# UNITED STATES PATENT AND TRADEMARK OFFICE

APPLICATION NO.	FILING DATE	FIRST NAMED INVENTOR	ATTORNEY DOCKET NO.	CONFIRMATION NO.
10/596,250	06/06/2006	Rainer Durth	740116-608	4230

<b>Office Action Summary</b>	<b>Application No.</b> 10/596,250	<b>Applicant(s)</b> DURTH ET AL.	
	<b>Examiner</b> DHARTI H. PATEL	<b>Art Unit</b> 2836

**Fig. 3 Extracted from US 4769736**

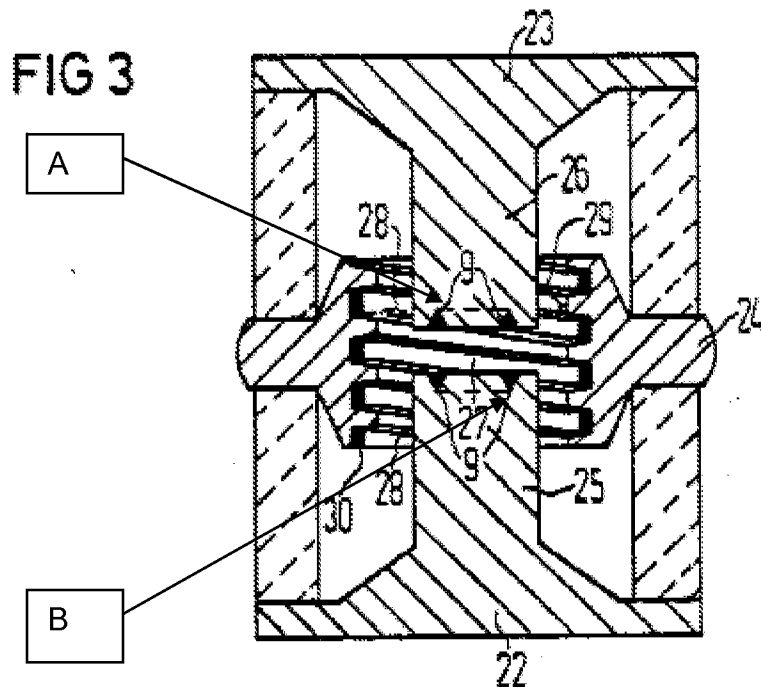
With respect to claim 13, Boy discloses an overvoltage protection means, comprising: a first electrode [Fig. 3; 22; col. 4 lines 64-65], a second electrode [Fig. 3; 23; col. 4 lines 64-65], a breakdown spark gap [Fig. 3; 27; 28; col. 4 lines 63-66] having a discharge space formed between the electrodes [Fig. 3; between the electrodes 22 and 23; col. 4 lines 63-66], an arc forming between the electrodes within the discharge space when the breakdown spark gap is ignited [col. 1 lines 35-47], and a housing [col. 5 lines 59-60] which holds the electrodes [Fig. 3; 22, 23], wherein the discharge space [Fig. 3; 27, 28] is configured in a manner which runs at least one of partially transversely and partially opposite a direction of an electrical field of a prevailing line voltage so that a distance to be overcome by the arc between the two electrodes has a component that is transverse relative said direction of the electrical field as disclosed; and wherein the discharge space extends from a radially outer area of the face of one of the electrodes [A; see the extracted Fig. 3 below; the discharge space coming from point A of electrode 23] to a diametrically opposite radially outer area of the face of the other of the

electrodes [B; see the extracted Fig. 3 below; the discharge space coming at point B of electrode 22].

With respect to claim 14, Boy discloses an overvoltage protection means wherein the discharge space has at least three regions, a first region of which is connected to the first electrode [Fig. 3; the first electrode 22 is connected to the discharge gap 28 at the lower left side of the electrode 22 as shown], a second region of which is connected to the second electrode [Fig. 3; the second electrode 23 is connected to the discharge gap 28 at the upper left side of the electrode 23] and a third region of which is connected between the first region and the second region [Fig. 3; subsidiary discharge gap 27 is connected between the first region and the second region].

With respect to claim 15, Boy discloses that the third region runs essentially perpendicularly to the direction of the electrical field of the prevailing line voltage [Fig. 3; the third region of discharge path 27 is arranged perpendicular to the electric field].

With respect to claim 16, Boy discloses that the third region runs partially obliquely to the direction of the electric field of the prevailing line voltage [Fig. 3; the third region 27 runs partially obliquely, which is sloping or joining something at an angle that is not a right angle].

With respect to claim 17, Boy discloses the third region runs partially opposite the direction of the electric field of the prevailing line voltage [Fig. 3; when the third region 27 runs upward, it runs partially opposite the direction of the electric field].

Examiner points out that Boy reads on this limitation of "wherein the discharge space...of the other of the electrodes." [See above extract Fig. 3 and rejection]
